Docket No.: 50-412

Subject: Review of Beaver Valley Power Station, Unit 2

The purpose of this letter is to provide you with an additional evaluation in the areas of containment systems, structural and geotechnical engineering, power systems, and reactor systems. Enclosure 1 is a list of the open items resulting from this review and Enclosure 2 is the staff evaluation which should be incorporated into the BVPS-2 draft SER.

Fig. 2.5-1 Generalized Subsurface Profile at the BVPS-2 Power Block Area

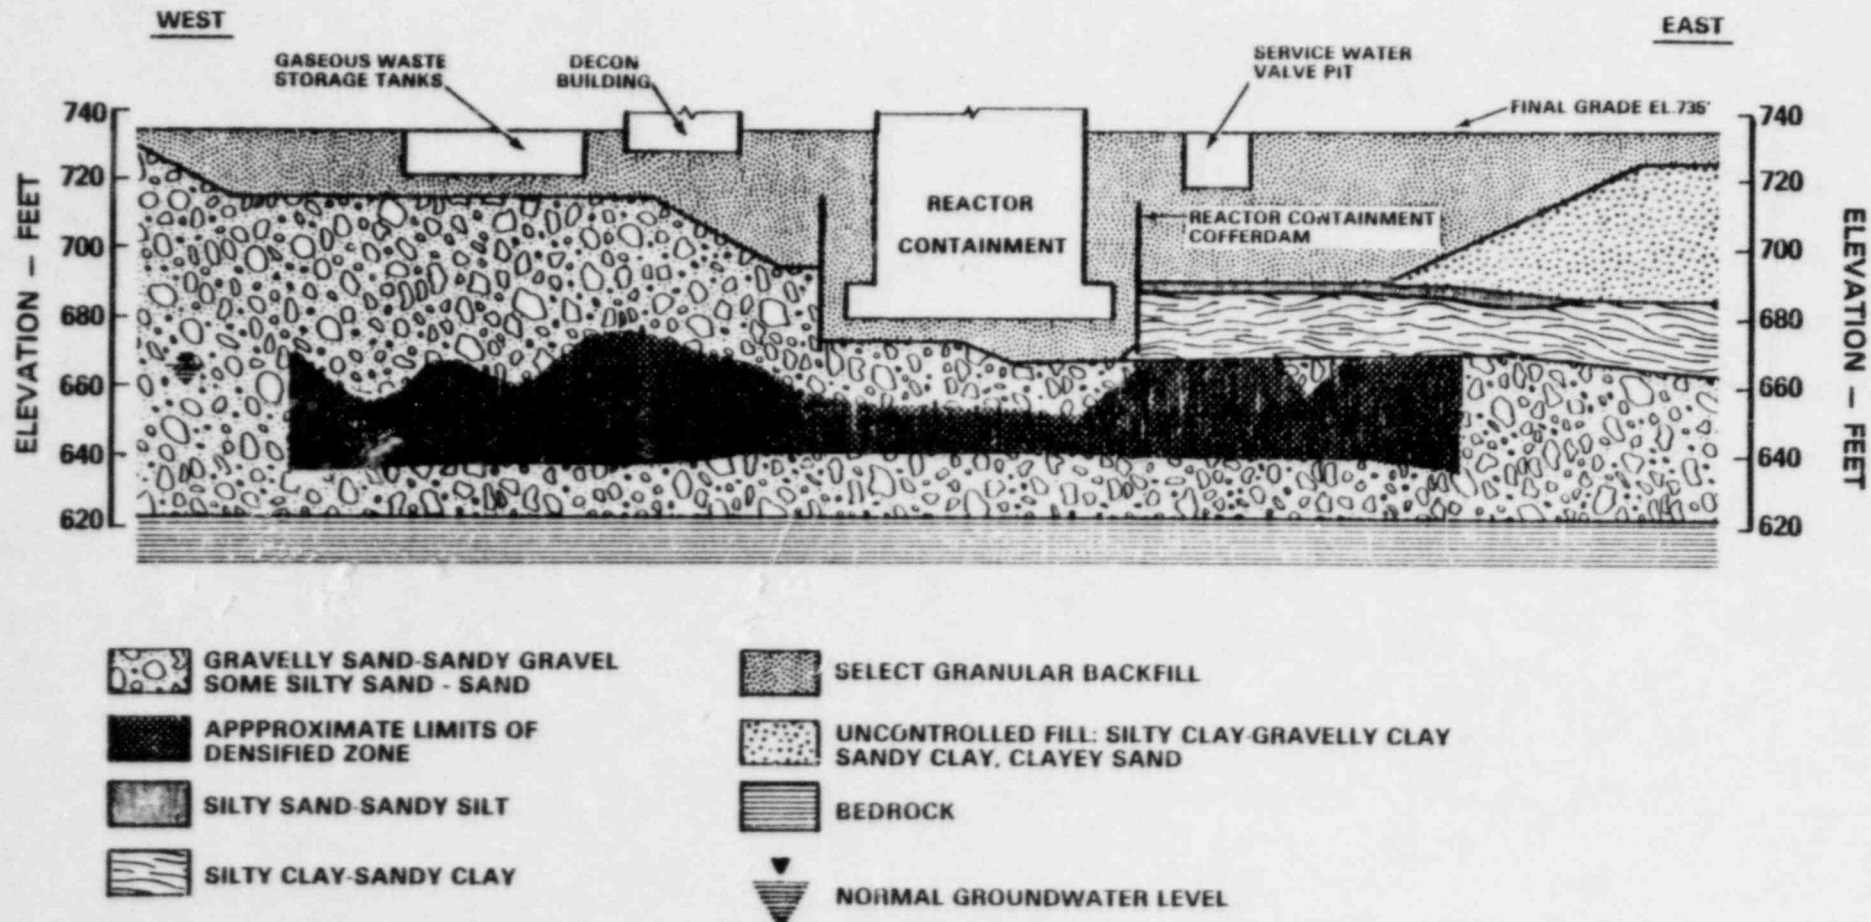
As shown in Fig. 2.5-1, the subsurface profile at the main plant area consists of about 115 feet of medium dense to dense granular soils (interbedded sands, gravels, and silty sands and gravels), underlain by shale bedrock at about el 620 ft. A zone of loose granular material was discovered in the containment excavation between about el 640 ft and el 660 ft and was densified under Category I structures using the pressure injected footing technique
